In the Matter of)
)
PACIFIC GAS AND ELECTRIC COMPANY)
)
(Diablo Canyon Nuclear Power)
Plant, Units 1 and 2)

TESTIMONY OF DR. ENRIQUE LUCO

Comments by

In compliance with the order of the Atomic Safety and Licensing Appeal Board (August 7, 1980, ALAB-640), I have reviewed the testimony offered by the parties and have considered the questions raised by the Board. My comments to the first six questions are included herewith.

Figure 6-5 (LUCCO)
 FIGURE NO. 38-3

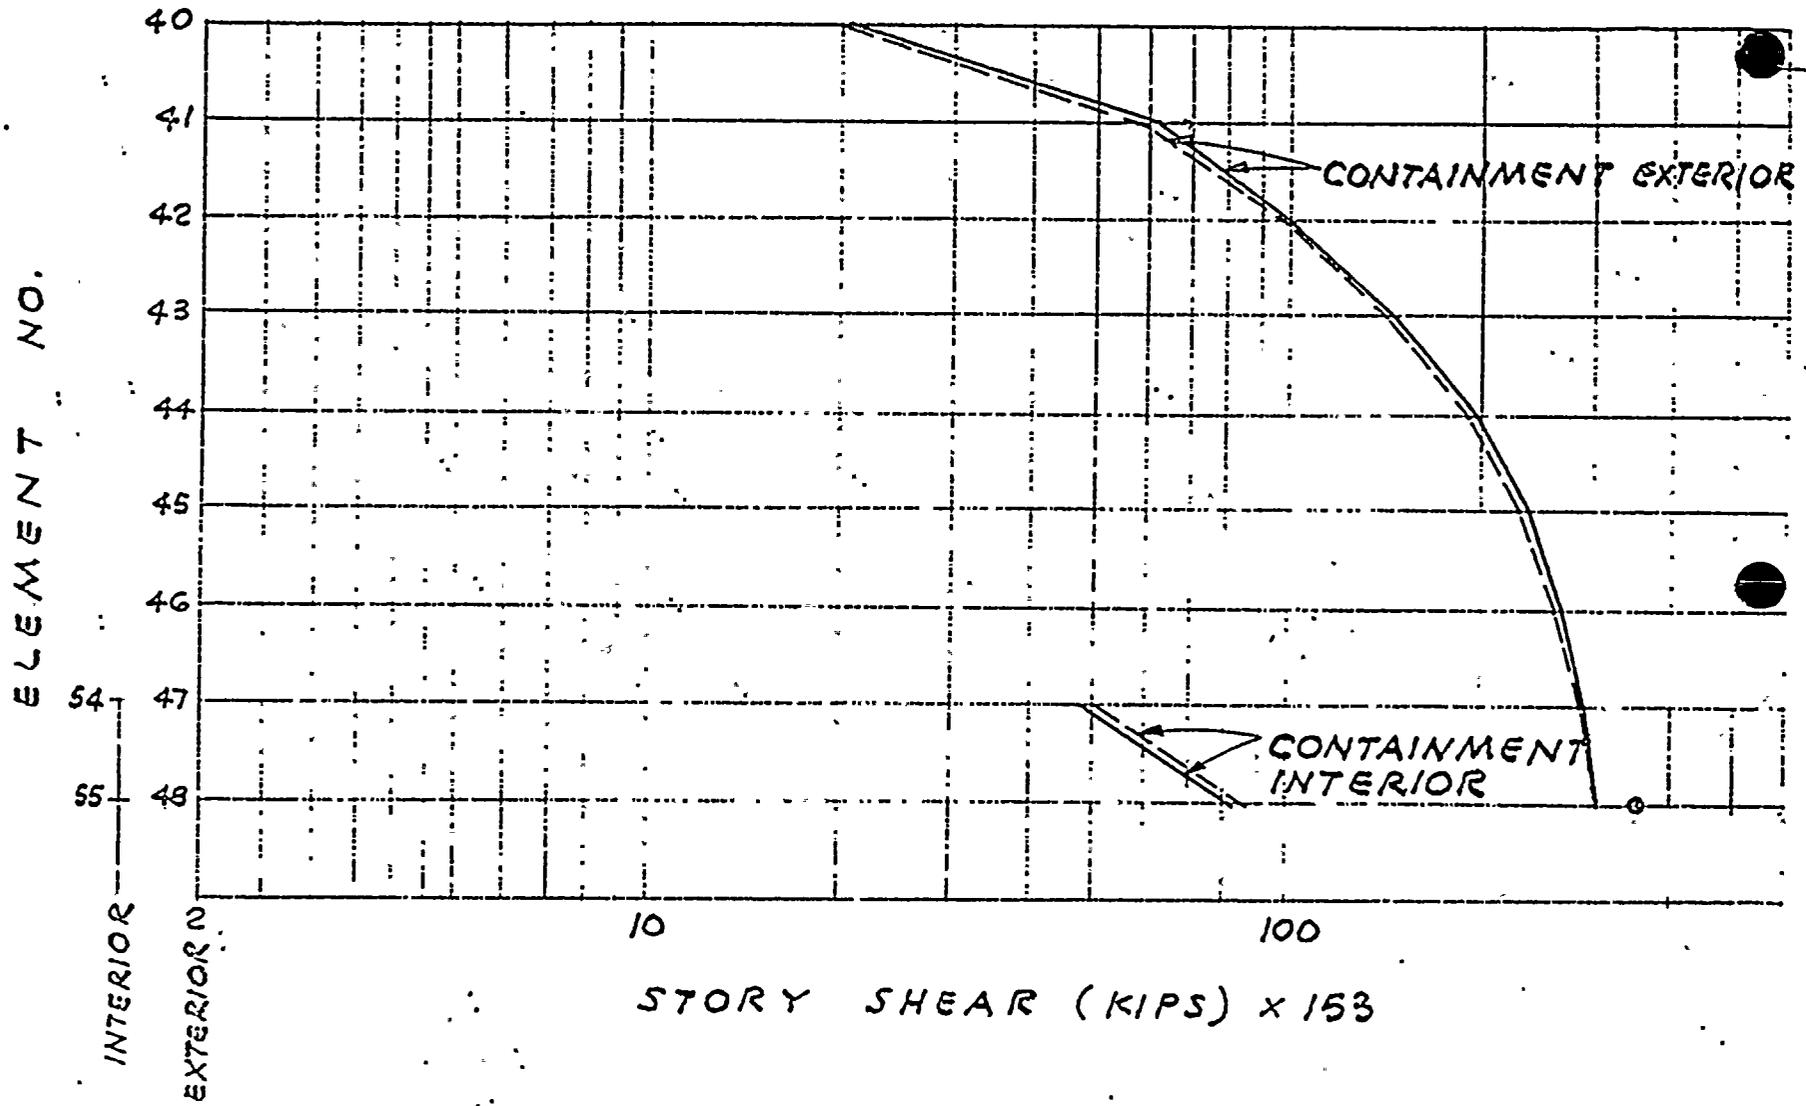
3. Effects of soil-structure interaction on internal forces. Analysis of the interaction problem reveals that and approximation to the ratio of the internal forces in the structure with interaction to the corresponding forces without interaction is given by $S_a(\tilde{\omega}_1, \tilde{\xi}_1)/S_a(\omega_1, \xi_1)$. In this ratio, $S_a(\tilde{\omega}_1, \tilde{\xi}_1)$ corresponds to the value of the absolute acceleration response spectrum at the system frequency $\tilde{\omega}_1$ and for the damping ratio $\tilde{\xi}_1$ (both terms including interaction). The term $S_a(\omega_1, \xi_1)$ represents the corresponding spectral ordinate at the fixed-base fundamental frequency ω_1 and for the structural damping ratio ξ_1 . For the containment building at Diablo Canyon, $\omega_1/2\pi \sim 5$ Hz, $\tilde{\omega}_1/2\pi \sim 4$ Hz, $\xi_1 = 0.07$ and $\tilde{\xi}_1 \sim 0.06$. Since the Newmark response acceleration response spectrum is flat for frequencies in the range from 2 to 10 Hz, the ratio $S_a(\tilde{\omega}_1, \tilde{\xi}_1)/S_a(\omega_1, \xi_1)$ would be equal to one except for the fact that the system damping is slightly lower than that for the structure. From this simplified calculation, we would expect the internal forces in the containment

building to be slightly higher when soil-structure interaction is considered. This conclusion is confirmed by the results of Seed and Lysmer (Appendix DLL-3B) reproduced in Fig. 6-5. The results in Fig. 6-5 show that the shear forces on the containment exterior shell are slightly higher when soil-structure interaction is included. Similar results are obtained for the flexural moments.

Clearly, general claims of the conservatism of not including soil-structure interaction are not warranted.
